As a local resident in Dunstan Grove, I lodge my objection to the proposed Lindfield Learning Village Stages 2 and 3.

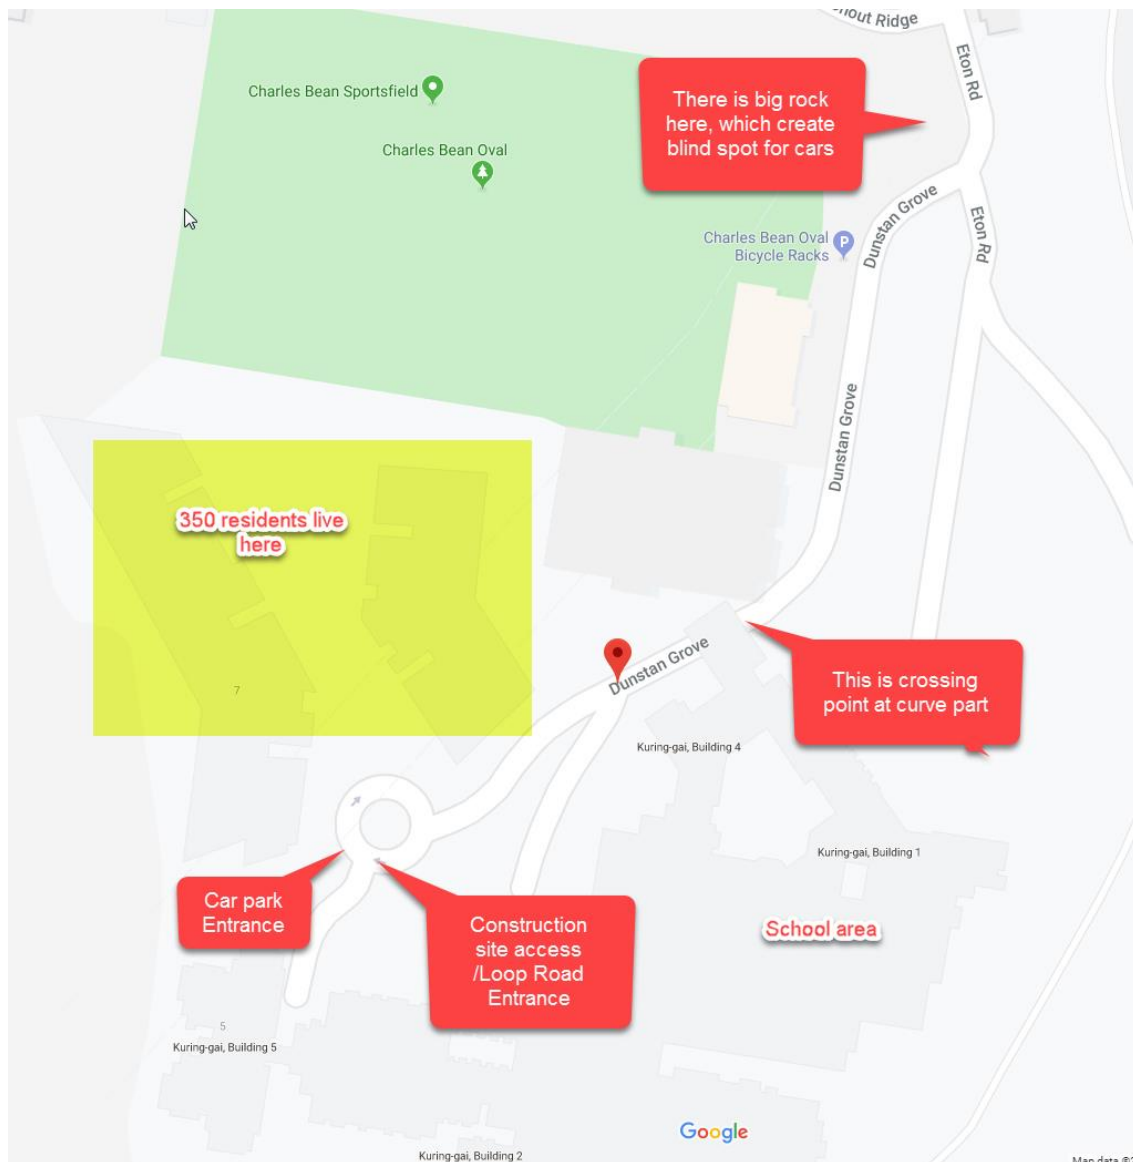
Whoever design this loop road for the school, the person never experiences what's the current situation of Dunstan Grove. Currently, there are roughly 350 people live in there and this is ONLY way for us go in and out. Dunstan Grove is narrow and curved road, it is already very tight for cars to pass each other, with limited sight lines. We've already had hundreds car go in and out. I DON'T think it can accommodate further 350 cars and 14 buses in the morning and afternoon during school period. And I'm sure these are conservative estimates from school. This equates to a car every 20 seconds and a bus every 8 minutes. If residents have any emergency service required, I don't think ambulance or fire fighter truck can make their way. This is serious consequence we are going to suffer.

Safety issue is the biggest concern of this loop road proposal. Again, Dunstan Grove is narrow and curved road, the curve part is a bit blind spot, it's very easy to cause car accident. There is no assessment of how buses can fit down the road safely with traffic travelling in the opposite direction. Schools Infrastructure has made NO attempt to demonstrate investigation of alternatives to the proposed Loop Road. School Infrastructure have clearly chosen the cheapest and easiest option for themselves, at the expense of the Dunstan Grove community, who will experience significant road and safety issues and increased congestion. Our Committee has provided 2 alternative proposals that keep the traffic on the eastern side of the site (within the school boundary) which would remove these safety issues. I want these to be further considered.

The map in the proposal is bit misleading, it doesn't show the surrounding apartments near school, which mislead people to believe loop road might work if you are not living there, but the reality is not. I really hope the decision makers should come visit Dunstan Grove once, you might surprise how narrow the road is and doubt the possibility of this loop road. I also include a copy of map point out some issue here.
